City of  
Richmond

## Report to Development Permit Panel

**File:** DP 22-013200

**Re:** **Application by Oval 1 Holdings Ltd. for a General Compliance Ruling at  
6011 River Road**

-Changes to exterior materials

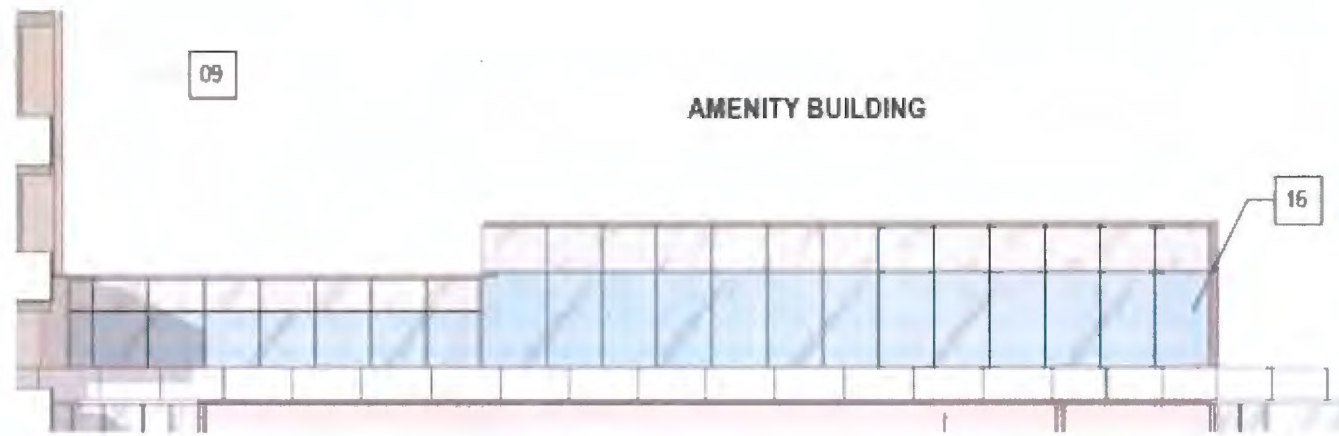
- The applicant proposes changing the cladding on a portion of the Towers A, B & C.
- High gloss metal panel cladding is proposed to replace the previously approved spandrel glass. The stronger contrasts between the glass and solid panels provide a distinct visual identity, ensuring the building stands out while maintaining a welcoming atmosphere.
- The updated design introduces subtle, darker tones and contrasting materials, offering a refined look.
- The change in material will have no impact to the thermal performance of the buildings.
- Though the material change will change the overall appearance of the building, the pre-finished gloss metal panel cladding achieves the desired colour and reflective quality that was previously approved with the spandrel glass cladding.

-Window wall system changed:  
Tower A, Level 9  
Tower B, Level 10

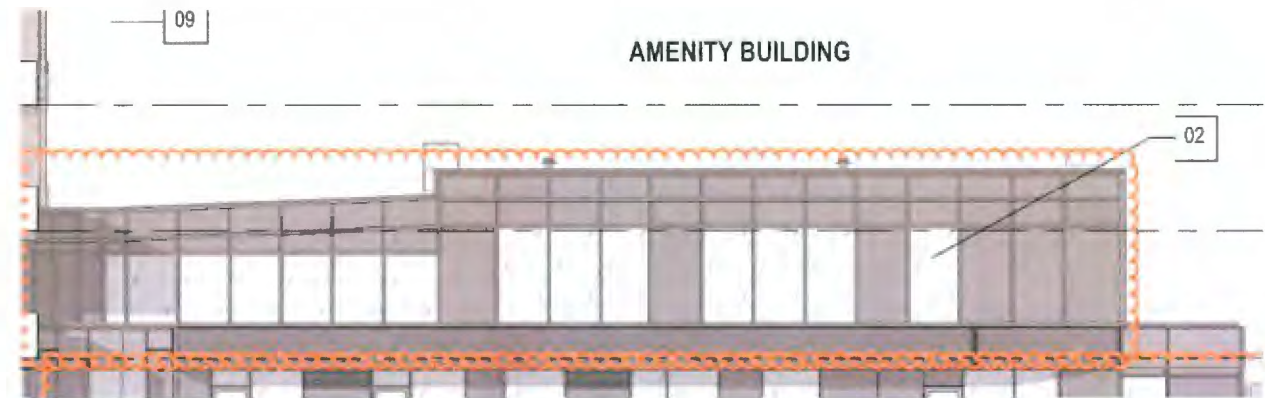
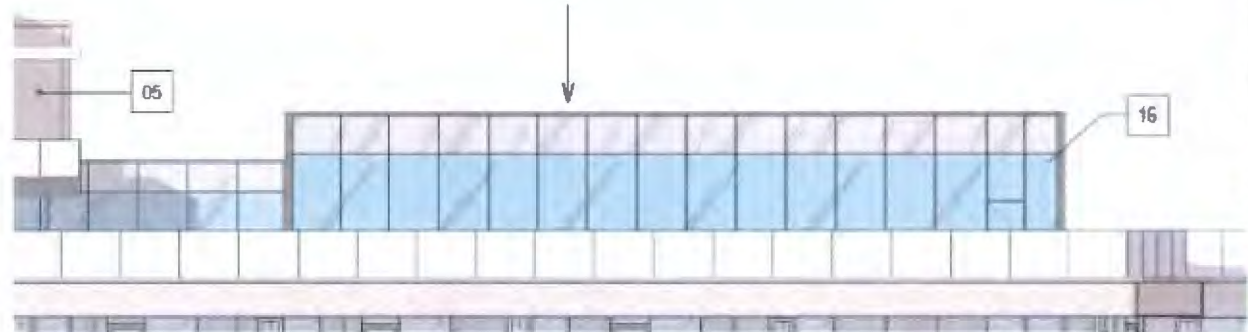
- A window wall system is proposed to replace the previously approved curtain wall system on the 9th Level of Tower A and the 10th Level of Tower B.
- The proposed curtain wall system introduces darker, more contrasting cladding materials, which add depth and visual interest to the structure.
- This change enhances the building's overall presence while providing the same design intent with minimal impact to the exterior appearance of the buildings.

-Changes to Level 2 common outdoor amenity area

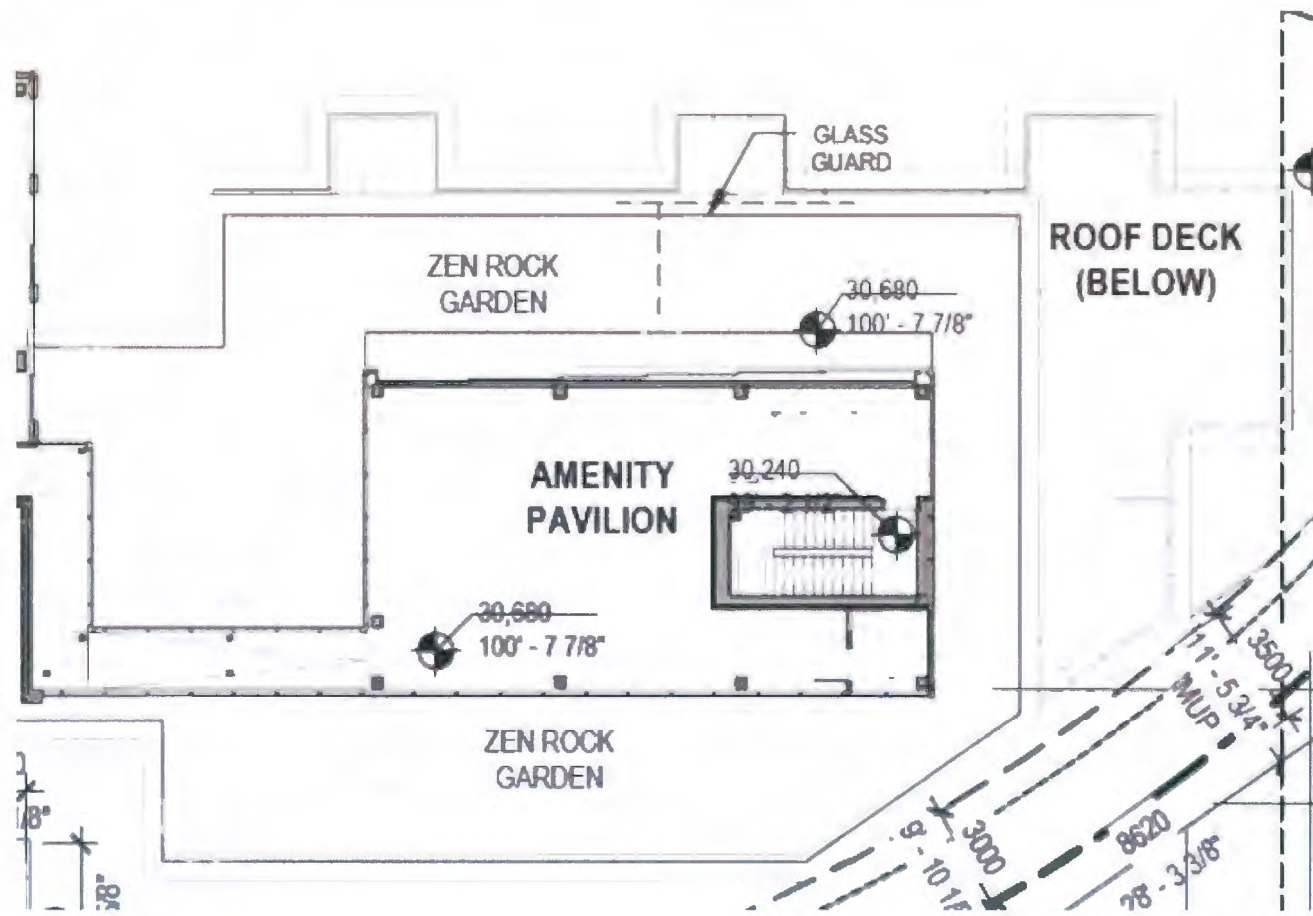
- The applicant is proposing changes to the outdoor amenity area located on Level 2 to enhance the overall versatility of the space for future residents.
- The applicant proposes to reduce the number of outdoor plunge pools from three to two.
- The additional space allows for the introduction of a dedicated Tai Chi deck as well as outdoor fitness equipment.
- The proposed amenity area is now proposed to contain both a sauna and a steam room, allowing for a compact hydrotherapy spa circuit.
- The proposed modifications to the Level 2 amenity area will increase the versatility and overall usability of the outdoor space.
- Other key aspects of the podium outdoor amenity space remain unchanged including the presence of ample seating, outdoor BBQ and dining areas, sunbathing areas, open lawn, bermed planting beds and edge planting.

-Improvements to Tower A rooftop amenity area

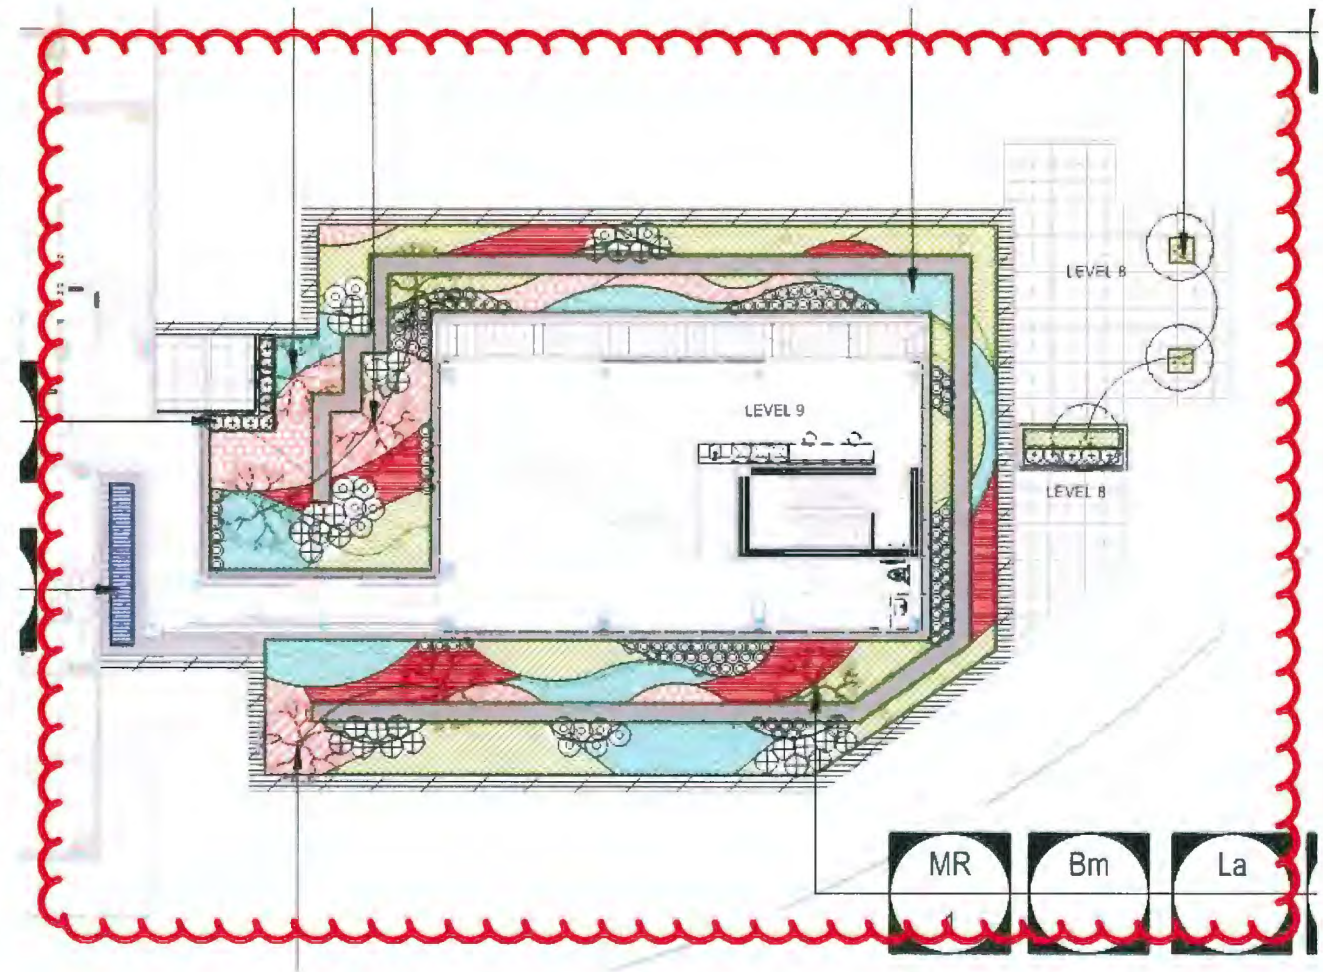
- The applicant is proposing minor changes to the rooftop amenity area of Tower A.
- The outdoor garden surrounding the indoor amenity pavilion at Tower A Level 9 is proposed to be revised from a Zen Garden to a garden containing more wildlife-friendly plants to attract birds, bees, and butterflies. The garden also includes a gravel path for maintenance.
- A private patio with hedging and screen was added adjacent to the garden for the southwest corner unit.
- In addition, the access corridor ceiling height leading to the amenity area has been increased to comply with Building Code requirements for minimum.

-Tower B amenity area and unit area swapped on Levels 1 & 10

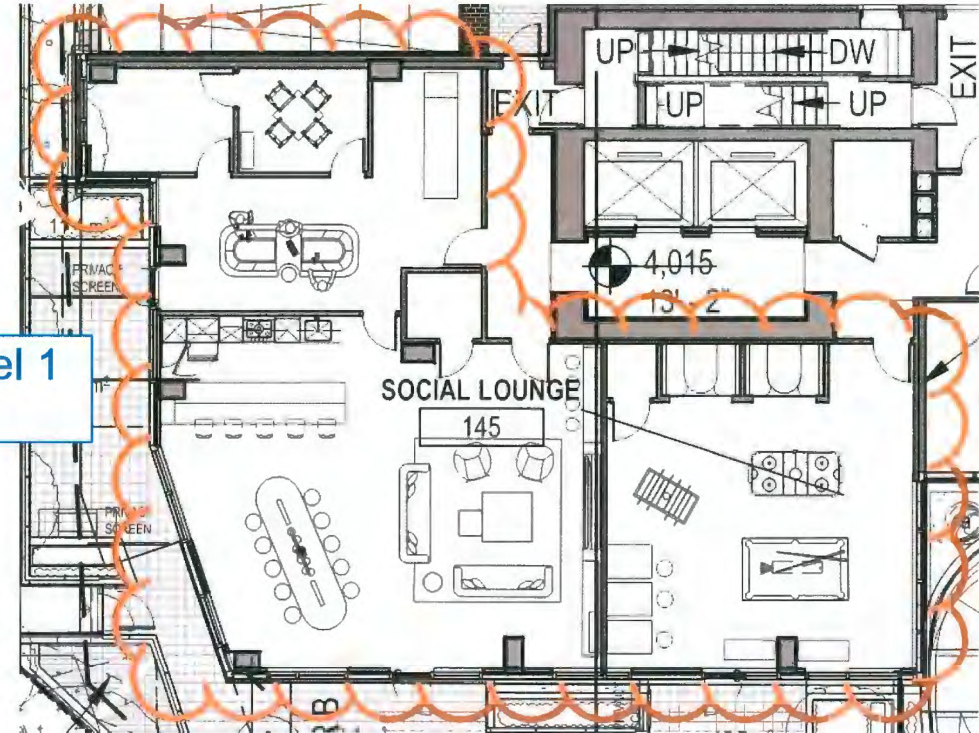
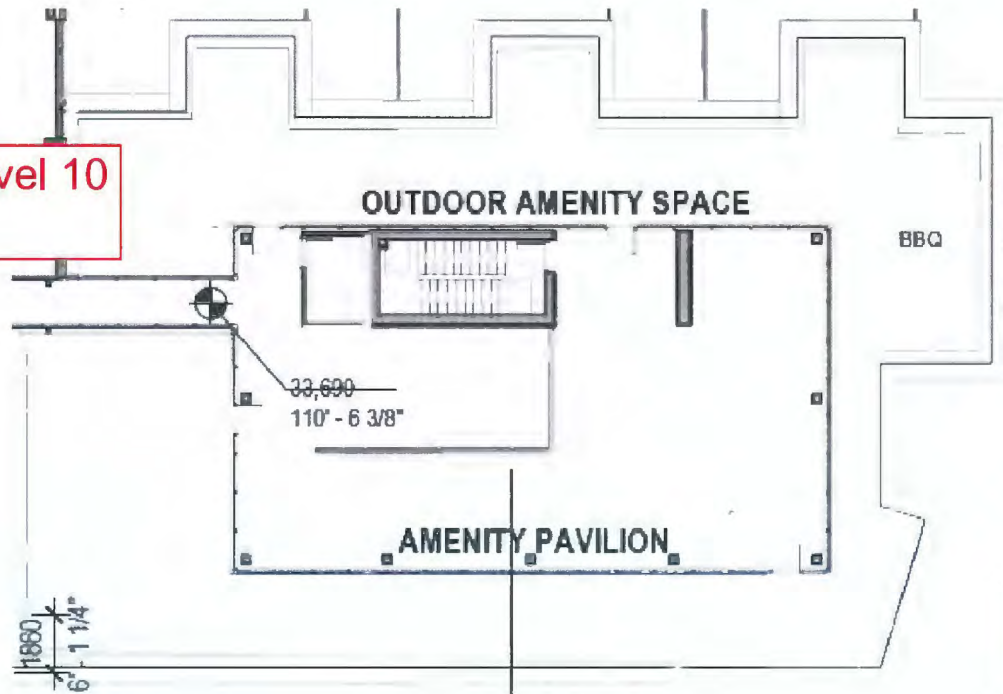
- The applicant is proposing to relocate the 10th floor indoor and outdoor amenity area of Tower B to the ground level at the southeast corner of Tower B, near the building lobby. This space was previously occupied by residential units.
- The ground floor amenity area includes the same features as the approved 10th floor space including outdoor BBQ and dining areas, social gathering areas, a fire pit and planting beds.

-Reduction in planted screens

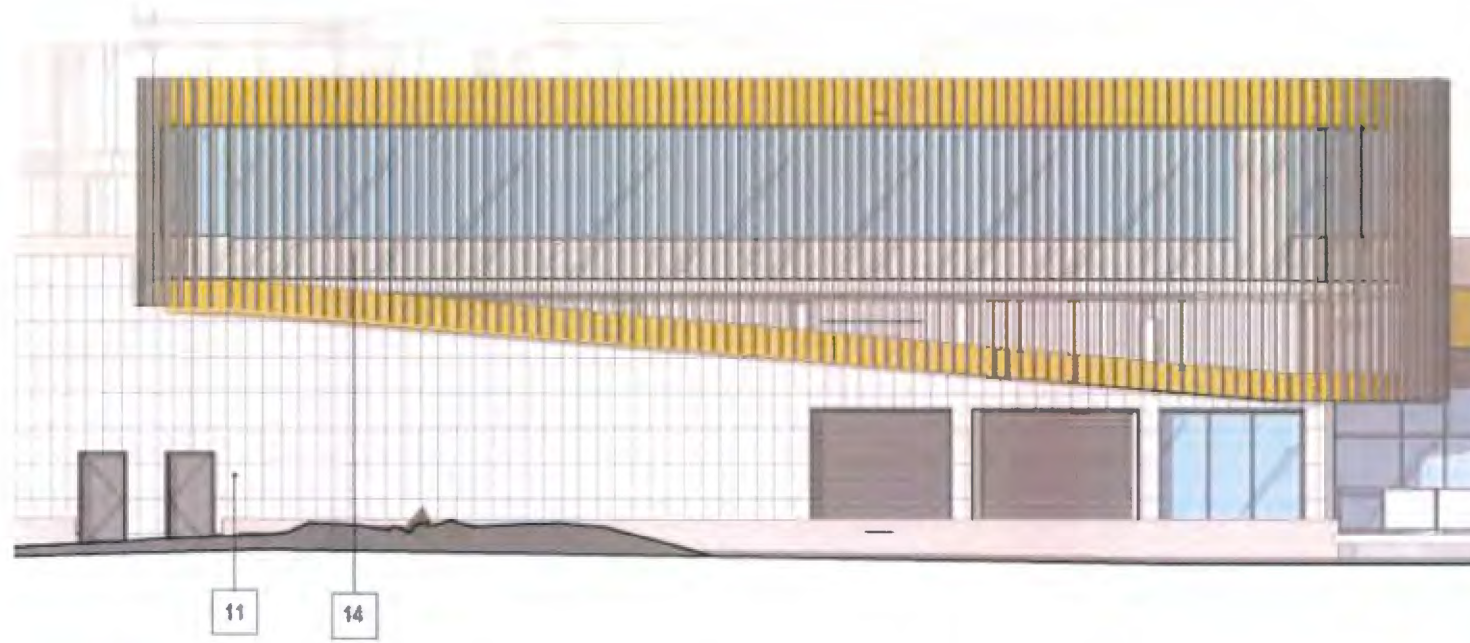
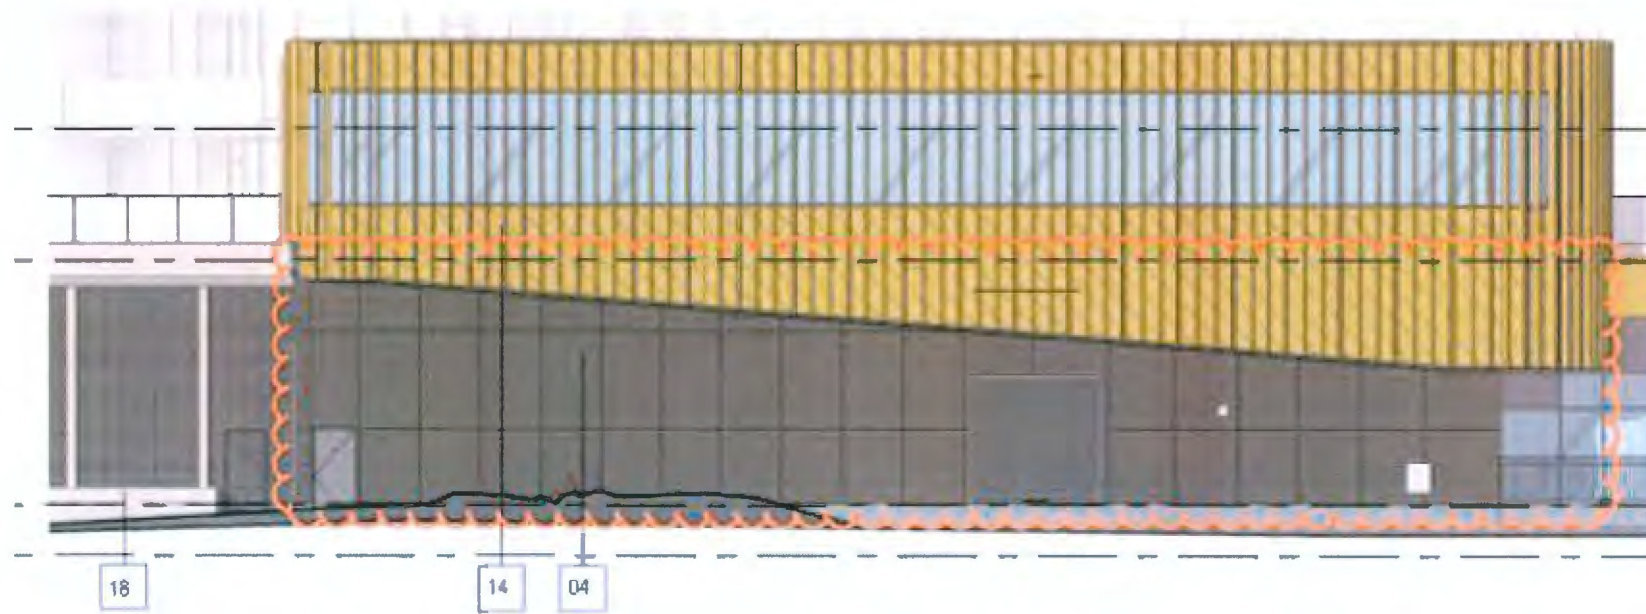
- The applicant is proposing to change the method of screening on a portion of the building façade adjacent the public walkway. A planted screen was previously approved along a portion of the building façade adjacent the public walkway.

- It has been determined through design review that there is not enough space to add planters along the edge of Level 2 with sufficient soil volume to allow vines to grow and cascade down the screen wall to screen the building façade on the ground level below. The applicants landscape architect has confirmed it is unlikely vines will be successful growing up from the ground level if planted there.

- Instead, the applicant is proposing to replace the planted screen with metal panels and cedar hedges located on the ground level. Other sections of the façade along the public walkway still contain the previously approved planted screen. The proposed cedar hedges would provide adequate screening of the building façade and maintain the original intent of softening this frontage with natural landscaping.

- Improvements to northwest edge planter at Level 2
- Private patio planter extended to ensure sufficient privacy from the common amenity area

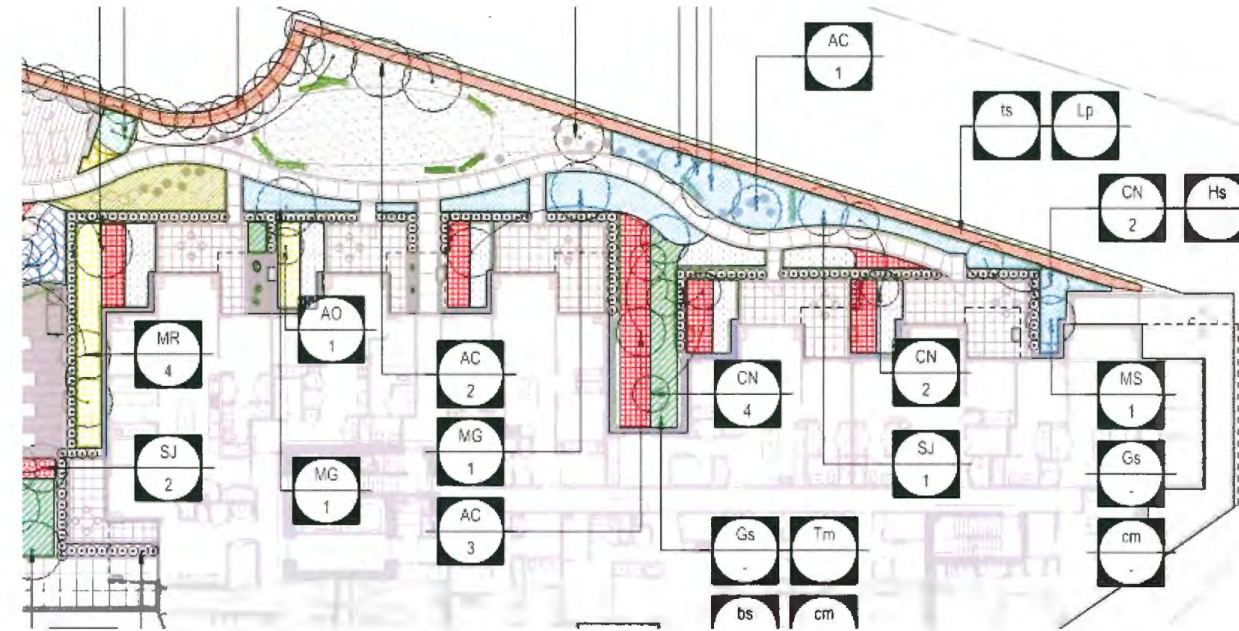
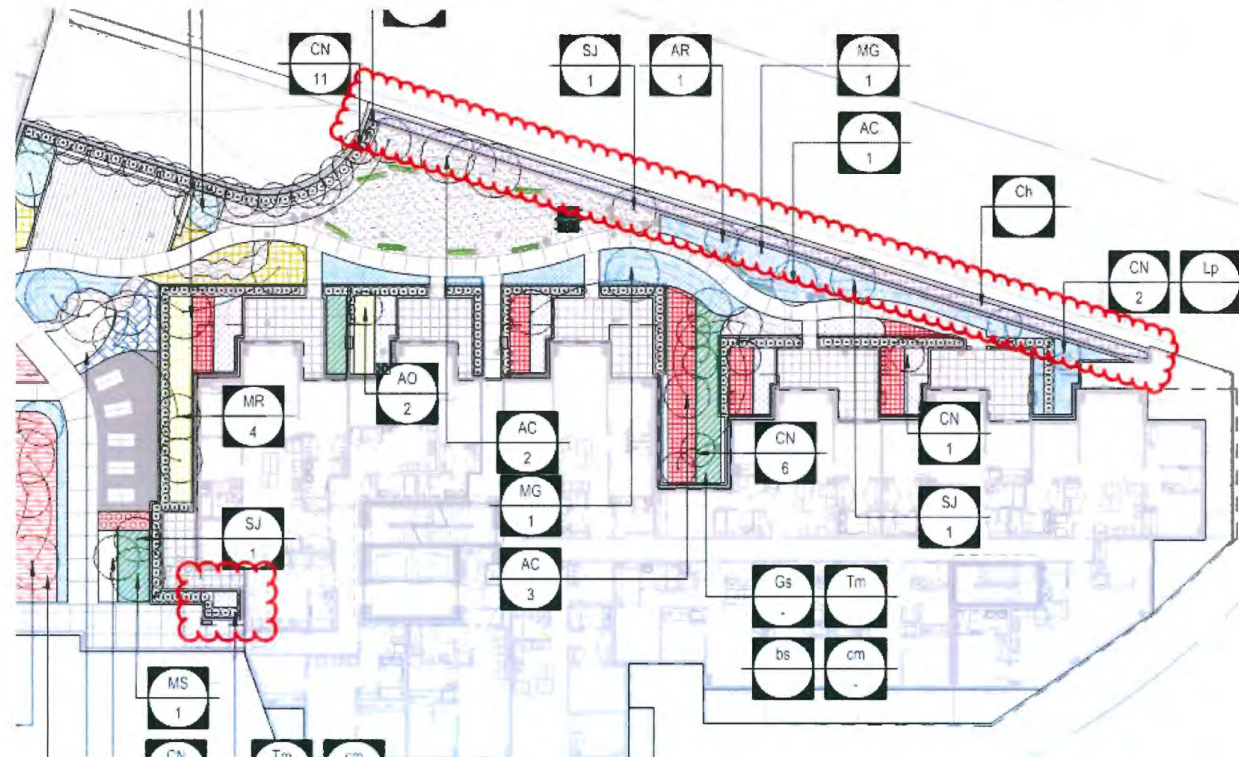
- The applicant is proposing changes to the northwest edge planter in the Level 2 amenity area, adjacent to the public walkway.
- The applicant is proposing to set the railing and parapet wall back to add a linear planter along the west façade with maintenance access for the future strata and to ensure the plants are able to successfully drape over the edge to meet with the evergreen climbing vines from below.
- This minor alteration will increase the likelihood of long-term planting success and ultimately lead to an improved screened area along the public walkway.
